CERTIFICATE OF APPROPRIATENESS

Property: 747 Arlington Street, Lot 1A, Block 258, Houston Heights Subdivision. The property includes a historic 1,568 square foot one-story wood frame single-family residence and detached garage situated on a 5,000 square foot (50' x 100') corner lot.

Proposal: Alteration – Construct a two-story addition and attached garage on top of and to the rear of a one-story Contributing residence.

Recommendation: Denial - does not satisfy criteria 1, 4, 6, 8, 9

NORTH SIDE ELEVATION—FACING 8TH STREET
EXISTING

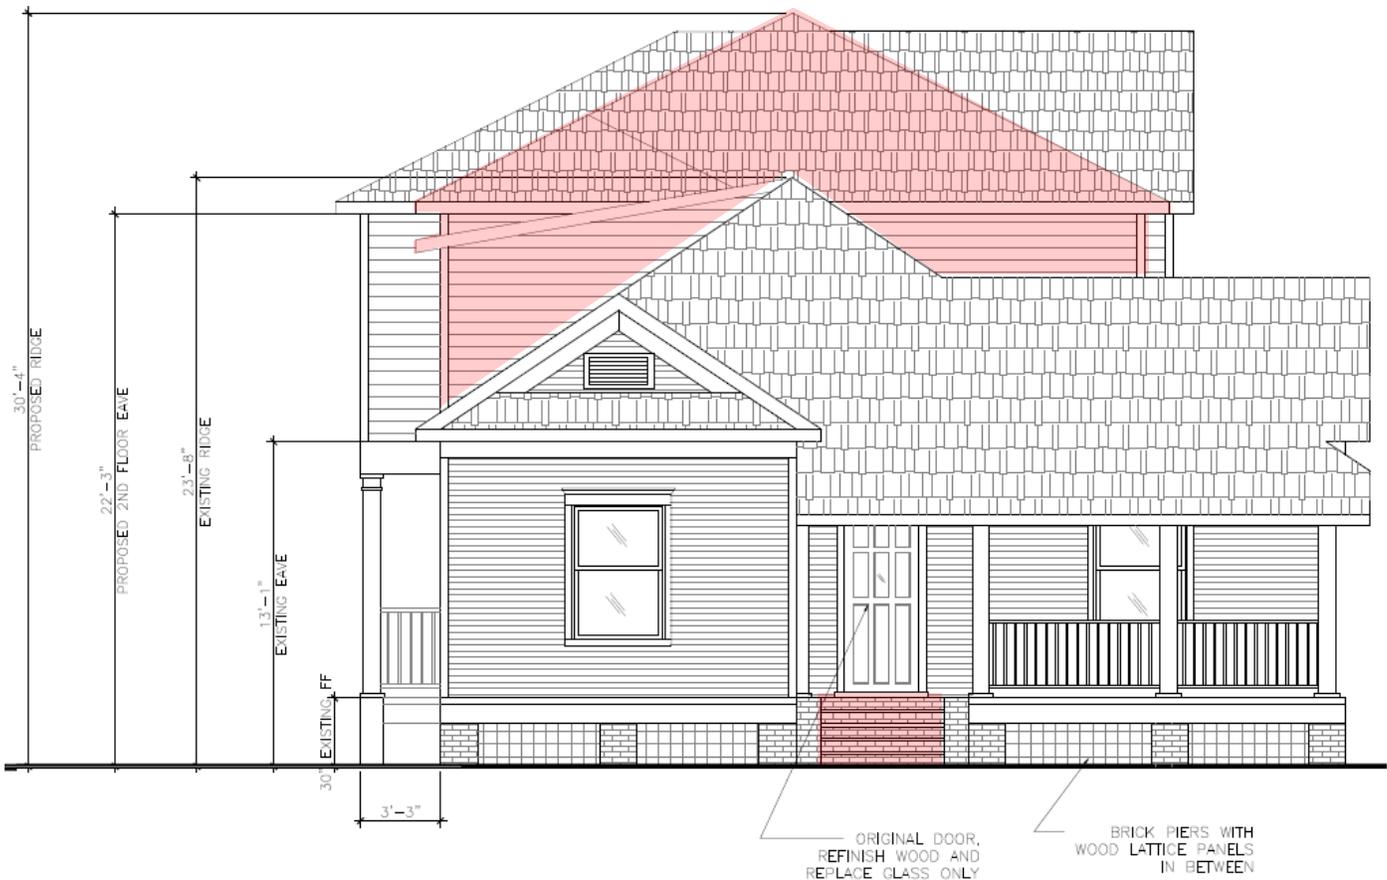
The encroachment of the proposed addition onto 50% of the original structure undermines the historic character of this property. The second story encroachment will permanently change the character of the structure from a modest one-story residence to a larger two story structure. . In order to maintain the historical character of the property, the proposed addition should begin at the rear wall of the original structure and be set in to distinguish between the old and the new.

The existing structure’s modest one-story stature is a distinguishing quality of this residence and others found throughout the district. The encroachment of a highly visible two-story addition over the rear half of the house negatively alters this distinguishing character. . The second-story portion of the addition should be moved farther towards the rear of the property in order to both minimize the visual impact and to preserve the distinguishing qualities of the building.

SOUTH SIDE ELEVATION

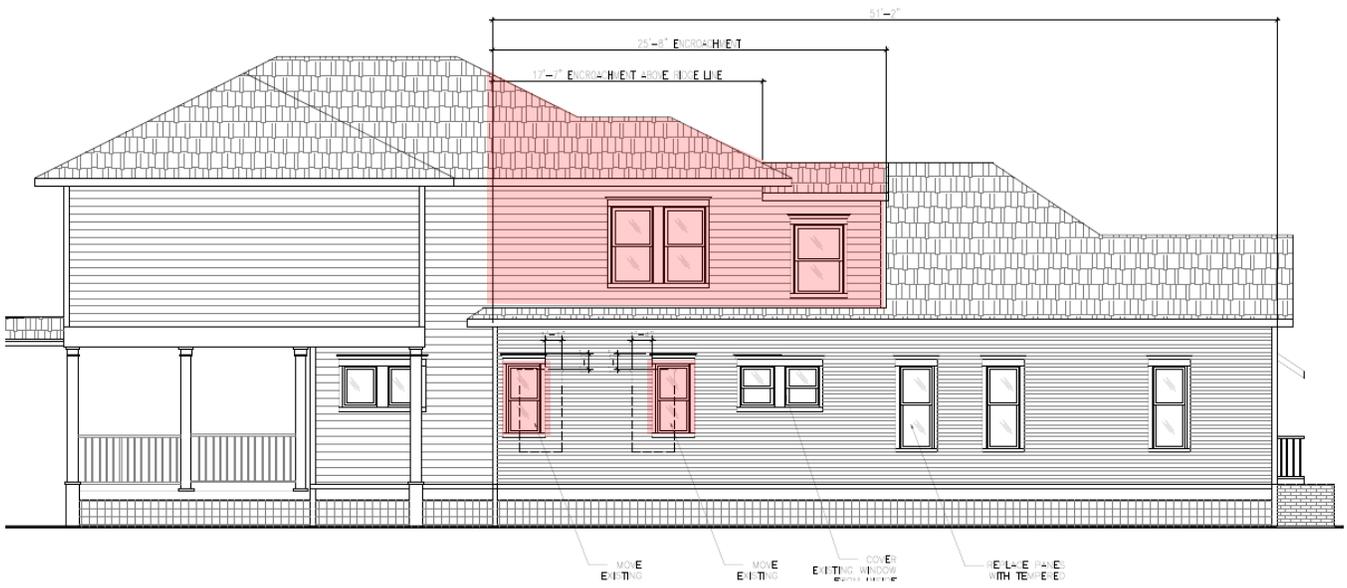
Constructing a second-story addition atop half of an existing one-story building while altering and adding window locations impairs the essential form and integrity of the existing one-story historic structure. The proposed addition should begin farther towards the rear of the property in order to preserve the essential form and integrity of the historic structure. Shifting windows in the original portion of the house will be extremely invasive. As this is a balloon framed house, the walls will have to be reframed and headers installed to allow for proper installation of the windows. Additionally, the walls will have to be reframed in order to support the added load of a second-story. This will not only lead to the removal of interior shiplap, but to the removal of the studs and portions of exterior siding, and roofing material.

The proposed two-story addition as well as the window alterations removes a significant portion of historic material while the proposed brick steps are not historically compatible within the district. The integration of the second-story addition atop the existing structure will lead to the loss of roofing and framing material while reinforcing the interior framing of the structure to support the added load will lead to the destruction of existing shiplap, siding, and framing material. Since this a balloon framed house, moving and altering several windows on the north and south elevations will necessitate additional existing wall material, shiplap, framing, and siding to be removed. The second-story addition will begin 50% back from the front wall, destroying half of the existing roof structure and impairing the character of the one-story Queen Anne cottage.

PORCH DETAILS

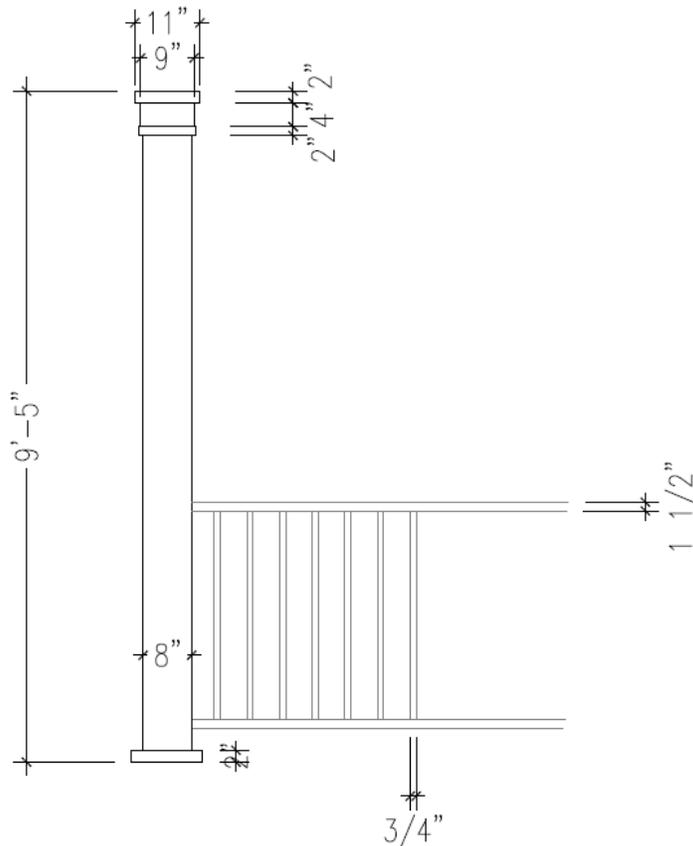
The proposed brick steps leading to the front porch are not a compatible feature typically found on contributing structures within the district. Replacing the existing masonry steps with brick steps is not an appropriate alteration. A more compatible step material would be wood or concrete.
- (7) The proposed replacement of missing exterior features, if any, should be based on an accurate duplication of features, substantiated by available historical, physical or pictorial evidence, where that evidence is available, rather than on conjectural designs or the availability of different architectural elements from other structures;
